Access Compliance Report

Public Rights-of-Way

Intersection ID: 20460	Main Street: RANLEIGH_LN	Cross Street: RED_HICKORY_LN	Location: SW
ADA ID: 50D8F444ADA9	Ramp Type: Directional1	Initial Pass/Fail: Fail	Overall Compliance: No
		Severity Score: 8.75	
Codes/Mitigation Info/Possible Solution		Field Measurements/Component Compliance

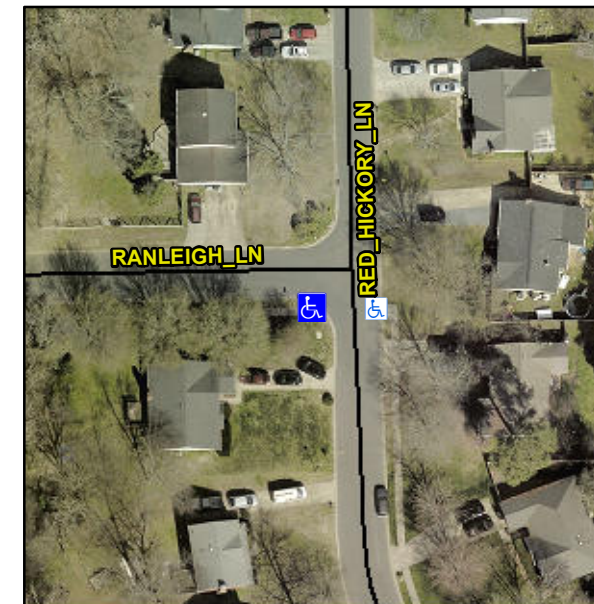
Remove & Replace Entire Ramp.

R304.5.1
